**Subject: Bid Package #2**  
Abbott Middle School HVAC Replcmt-DSA 01-119556  
George Hall Elementary School HVAC Replcmt-DSA 01 119523  
Laurel Elementary School HVAC Replcmt DSA 01-119551  
San Mateo - Foster City School District

### **ADDENDUM NO. 3**

San Mateo-Foster City School District  
HVAC Replacement Scope,  
Abbott MS DSA 01-119556  
George Hall ES DSA 01-119523  
Laurel ES DSA 01-119551

## 7 WALL INTERSECTIONS

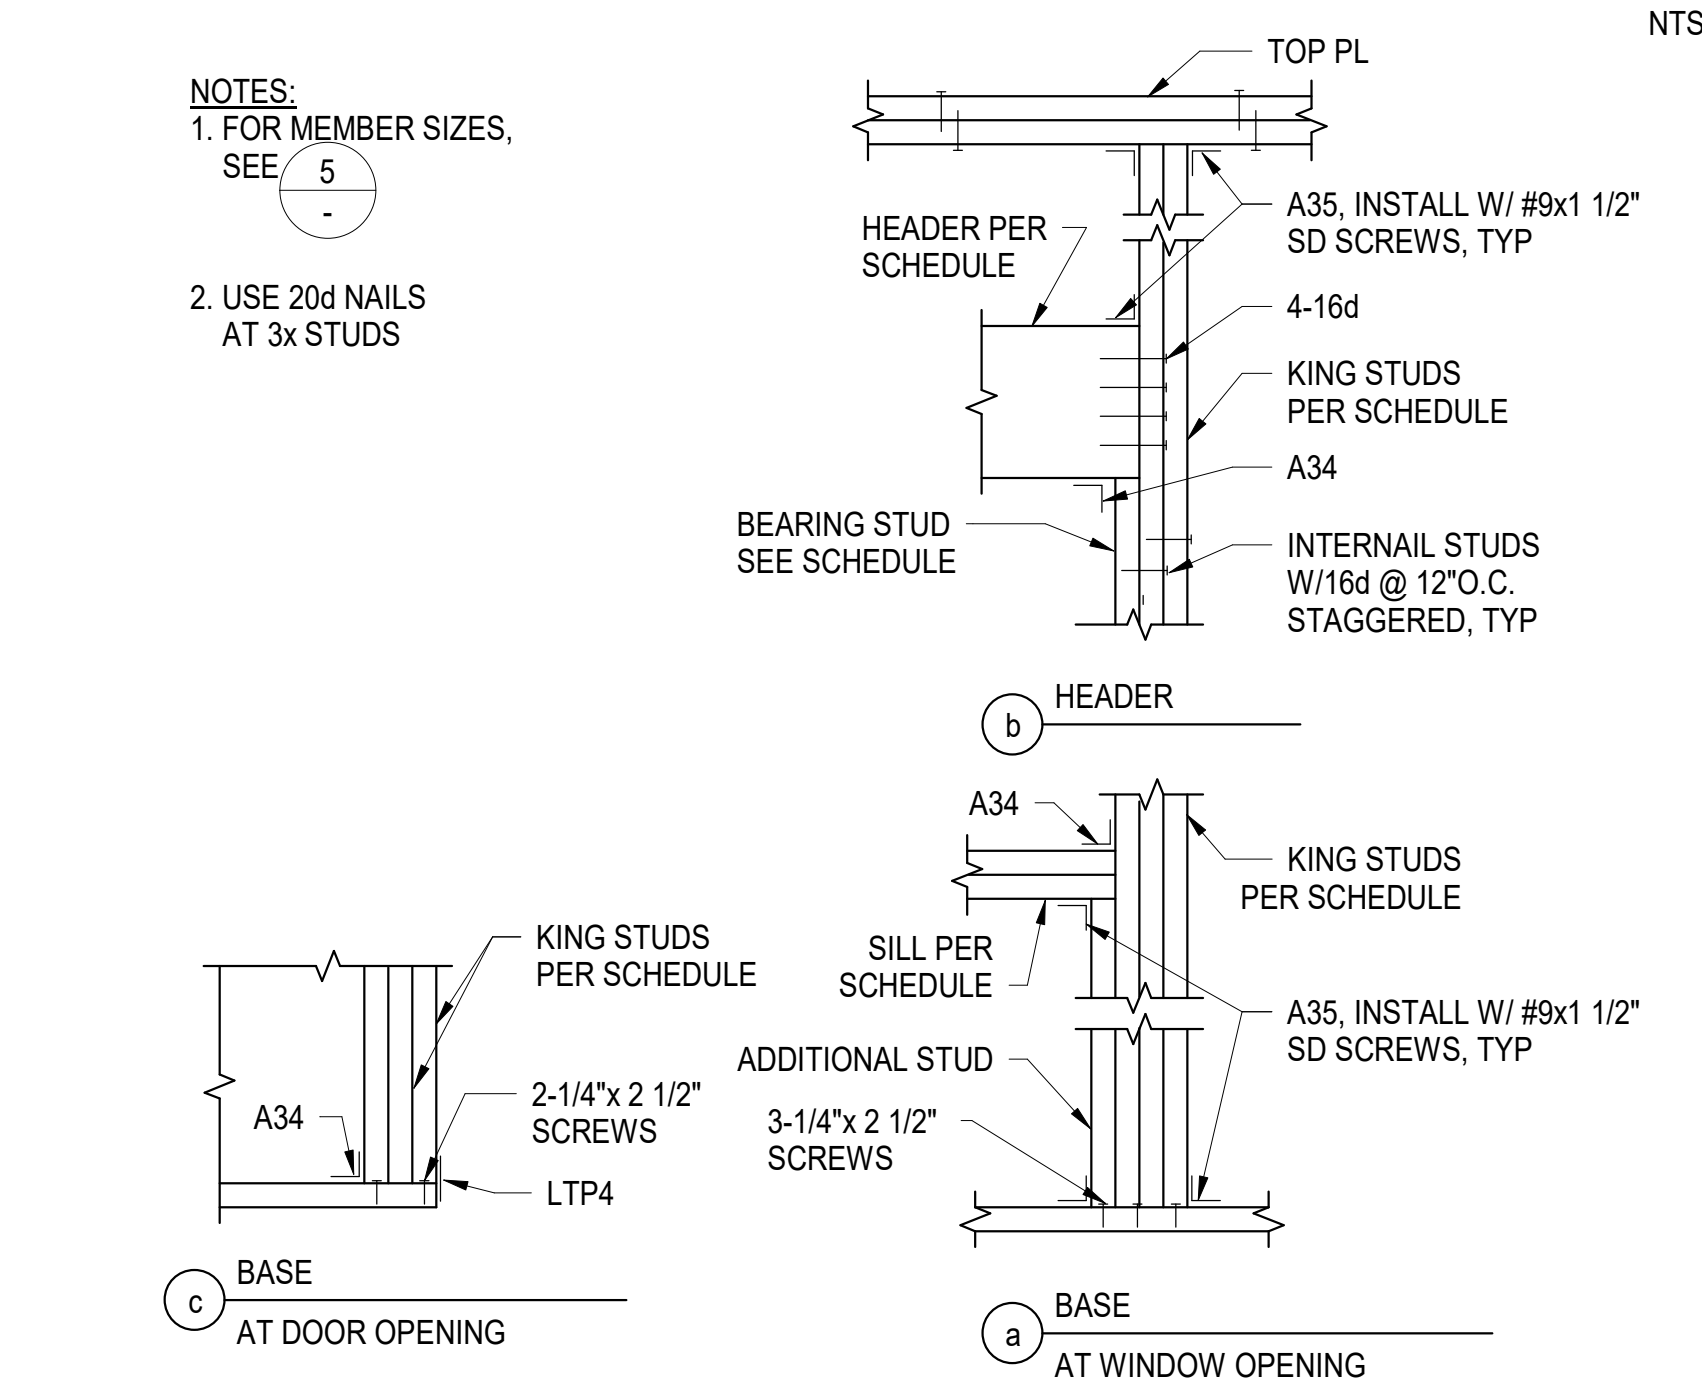
ITEM NO. 3.21:     DRAWING SHEET S8.01 – FRAMING DETAILS AND NAILING SCHEDULE

Remove:     Vertical nailing requirement in detail 7 per Attached AD3-S8.01

1  
E1.1  
SCALE: 1" = 20'-0"

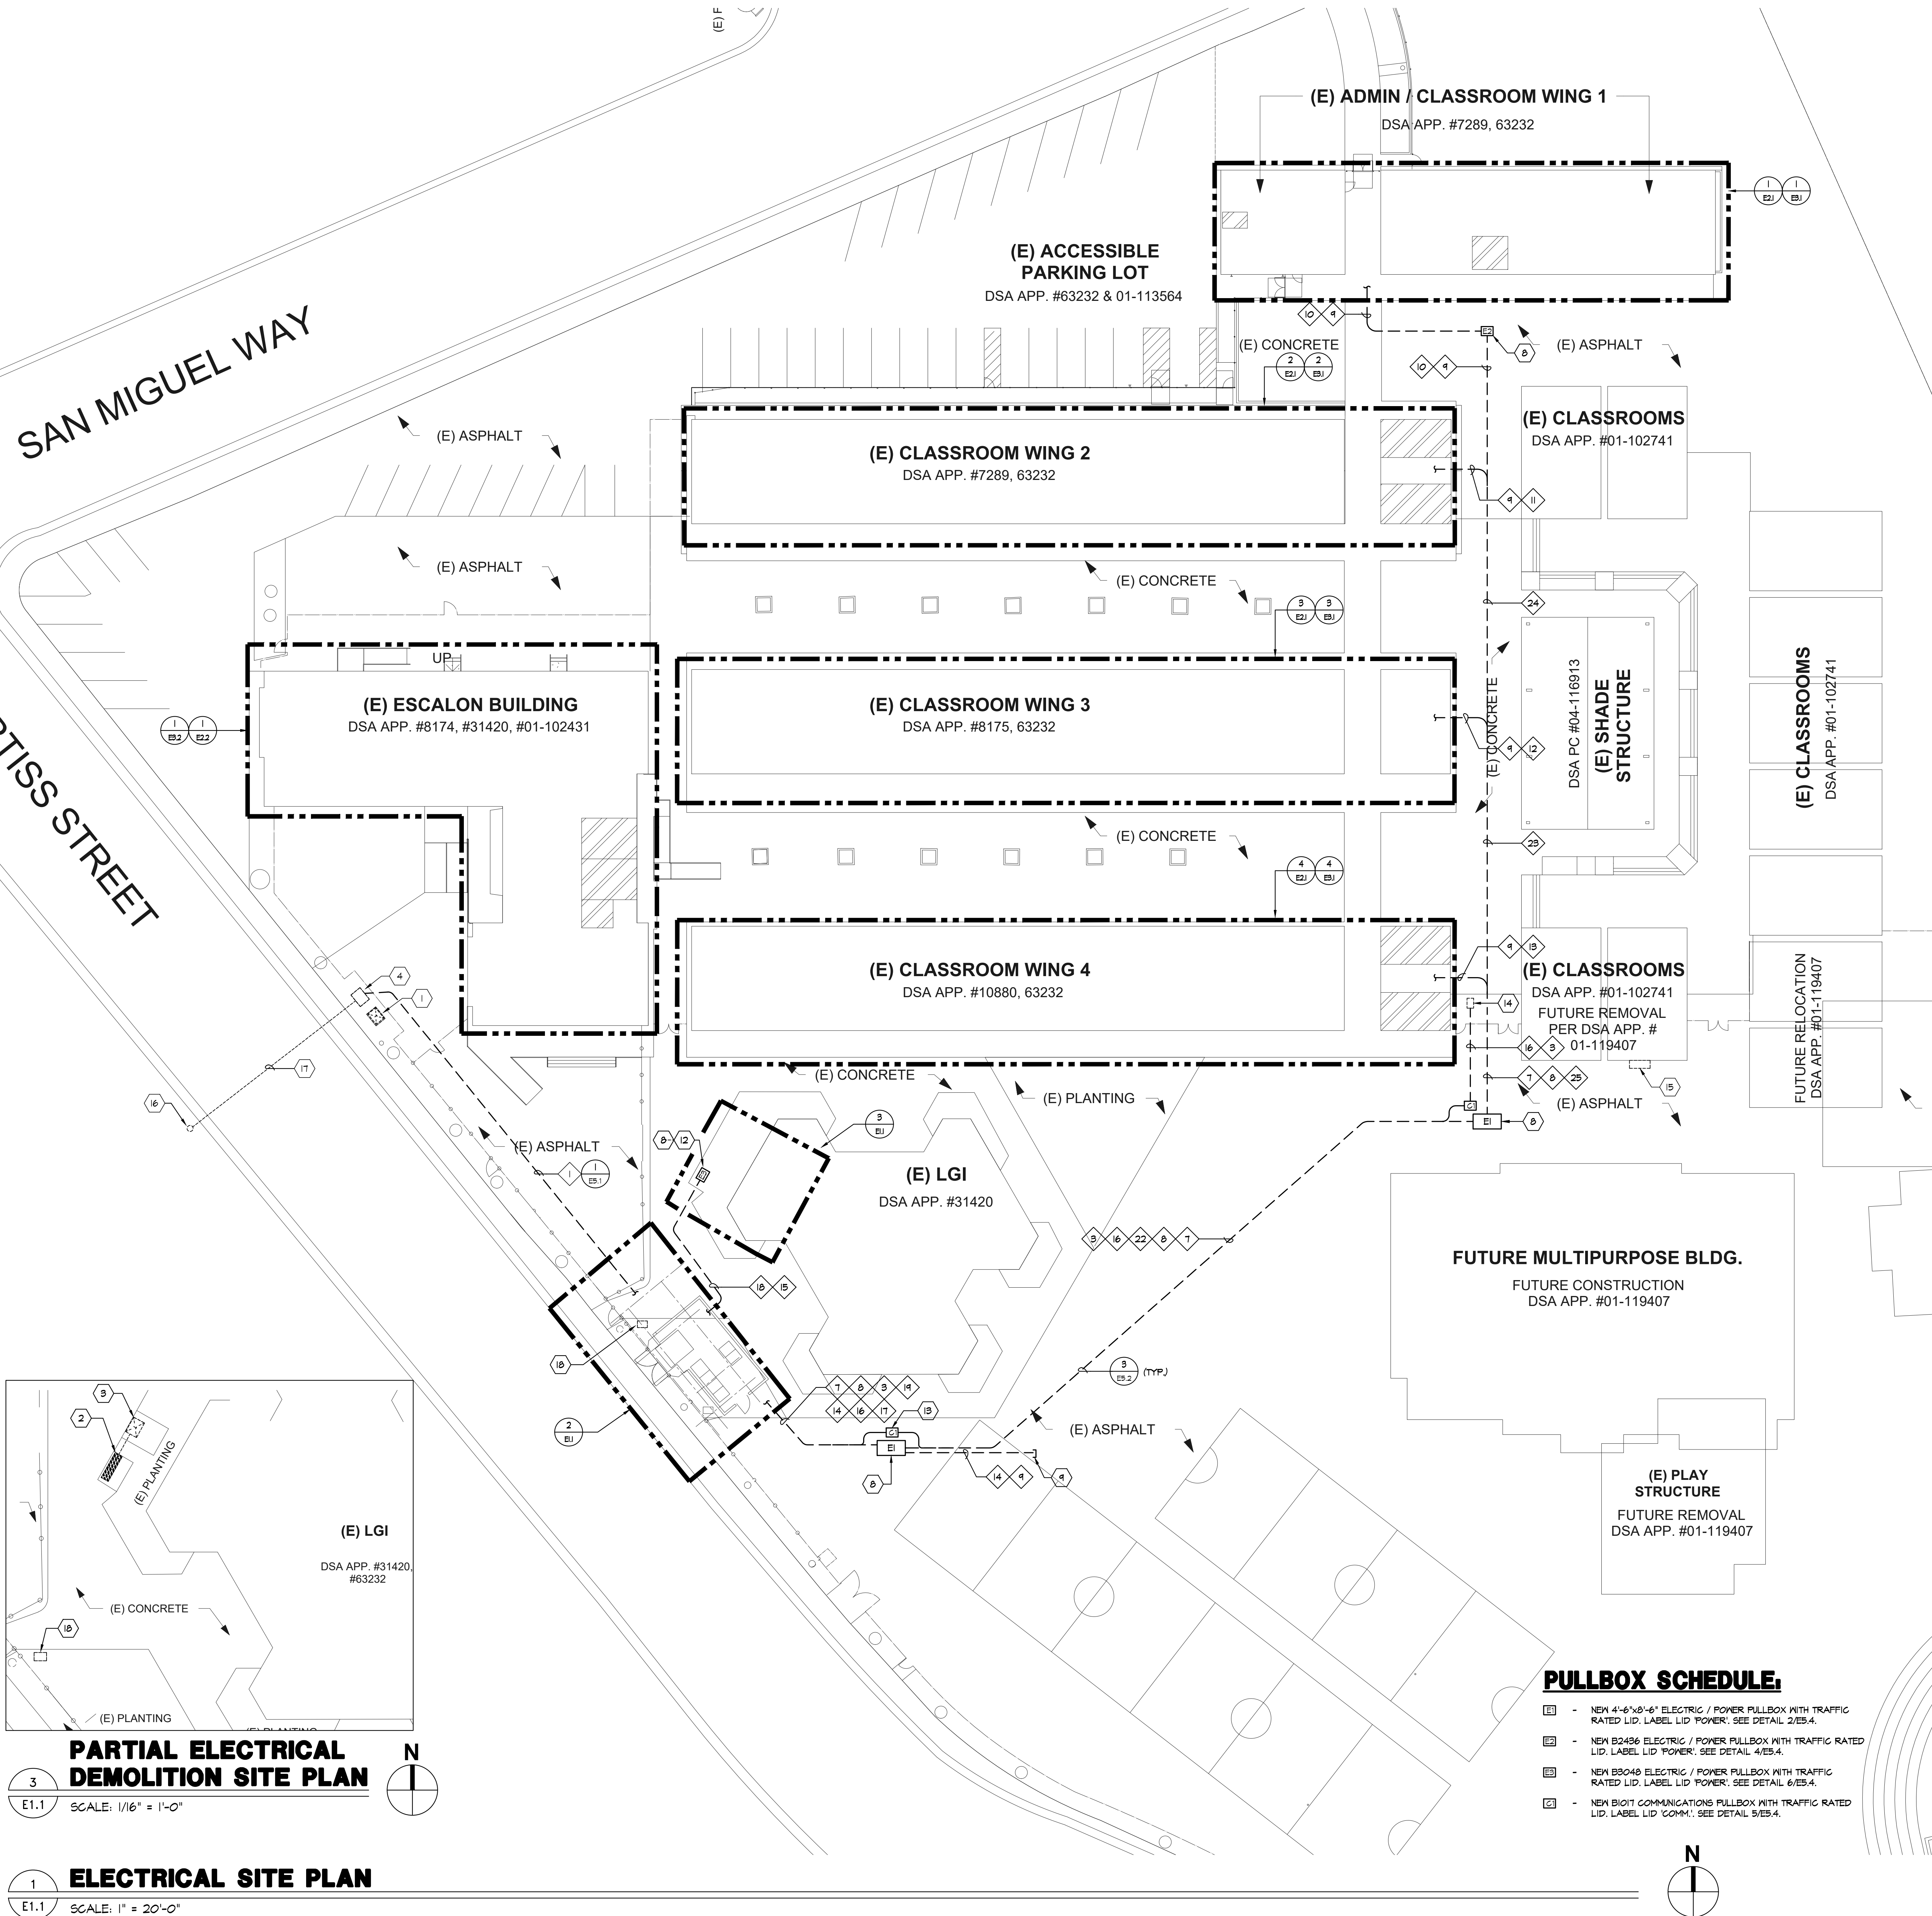
ITEM NO. 3.29:     DRAWING SHEET E1.1 Electrical Site Plan

Revise:     General Note #2 per attached AD3-E1.1.
